DEVELOPMENT REVIEW COMMITTEE (DRC) COMMENT REPORT

PROJECT NAME: Broward County Convention Center and
Headquarters Hotel

CASE NUMBER: PLN-SITE-20040005

REQUEST: Site Plan Level II Review: 1,167,826 Square Foot
Convention Center, 15,000 Square Foot Restaurant Use
and 800-Room Hotel with Shared Parking Agreement

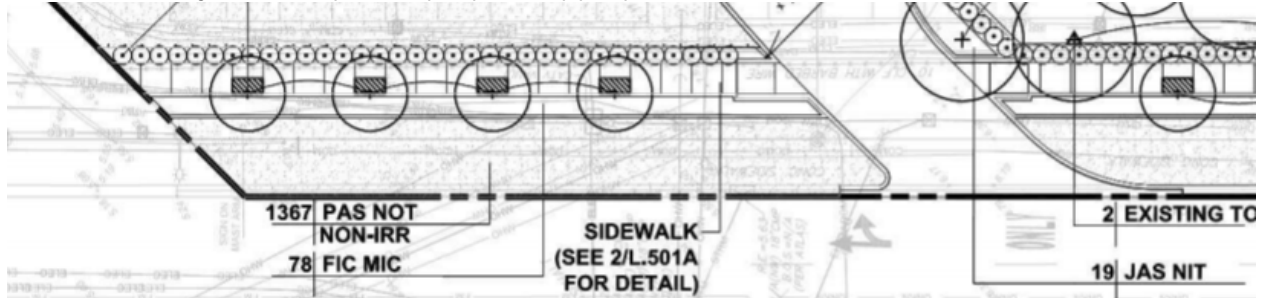
- a. Demonstrate hashing on landscape, site and civil plans as to the extent of use of the Structural Soil.
- b. Provide Structural Soil Detail and composition.

There is a product that the Landscape Department will approve the use of in place of Structural soil. With the Structural soil repositioning of the underground utilities is required. A suspension modular paving system product will provide the required root development area for a healthy and vibrant tree, along with their use it will allow the utilities to be in place and not affect their location in conjunction with the tree's root system. Please look into the use of the Green Blue Urban soil cell, Silva cell or like product for this and all future site developments.

As with the use of Structural soil a detail of the product and indication of the extent of use to be provided of the soil cell pavement support systems product.

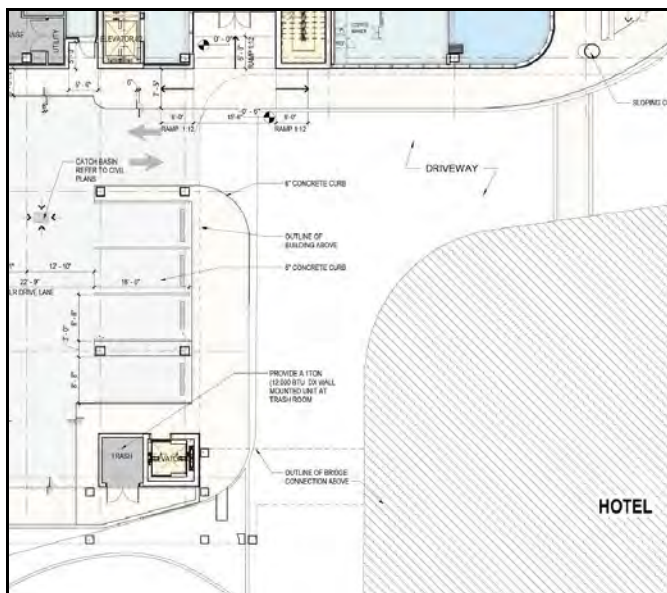
11. Sheet D-9, Ground Level Floor Plan: Hotel –
 - a. Provide dimensions of right-of-way width on Architectural and Site Plans, such as Sheet D-9 and C-100 for easier reference of project circulation.
 - b. Some of the C.C. Drop Off area seems to be wide enough to allow for two-way traffic. Is there a reason there are two lanes (one wide enough for two cars) with a median to make a left turn on the spine road, parallel to Grand Drive? This may cause safety issues when vehicles are trying to turn left on to on-coming traffic. See figure below.

- c. Consider refining drive-aisle direction at mid-entryway from spine road to optimize functionality of vehicular turn to make a left heading east to the Porte-Cochere area. See figure below.

12. Provide pedestrian crossings with safe refuge opportunities from vehicular traffic. For instance, are there pedestrian crossing connections from Grand Drive to internal spine road for access to hotel (depicted on figure above comment)?
13. Provide a pedestrian access and circulation plan that shows pedestrian connectivity throughout the site. Crosswalks and sidewalks should be wide and ample to enhance the pedestrian experience, accommodate higher volumes of pedestrians and provide other amenities for respite opportunities.

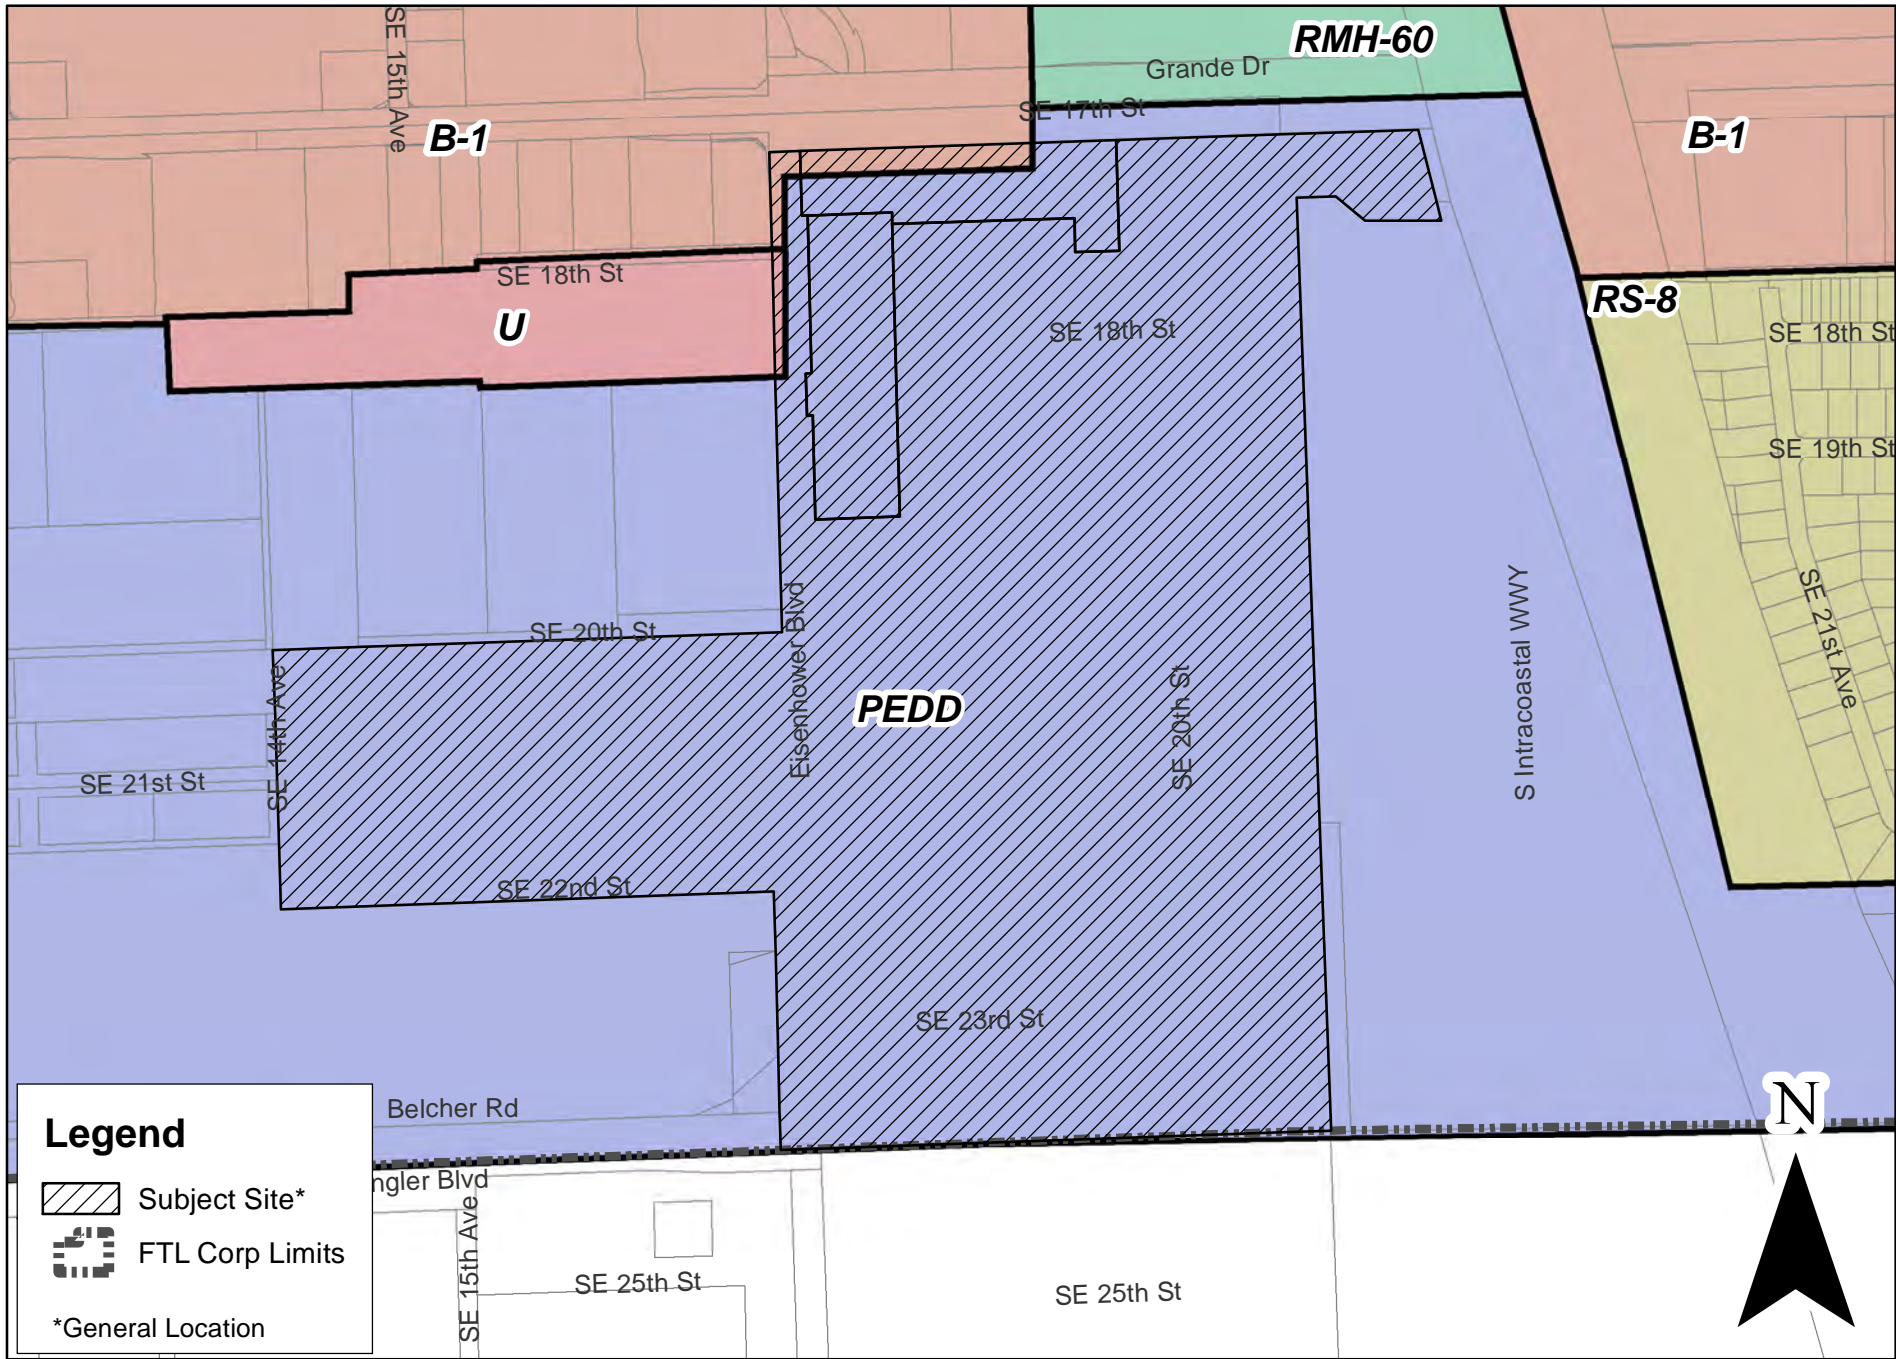
Pursuant to Ordinance No. C-19-26, DRI Development Order - Section 4.A.8 – Development Approval, The developer/successors, and/or assigns... shall incorporate energy conservation measures and green building design into the design and operation of the project with a goal of acquiring LEED “ Gold ” certification for both building construction and operations. Provide a point-by-point narrative indicating project’s compliance.
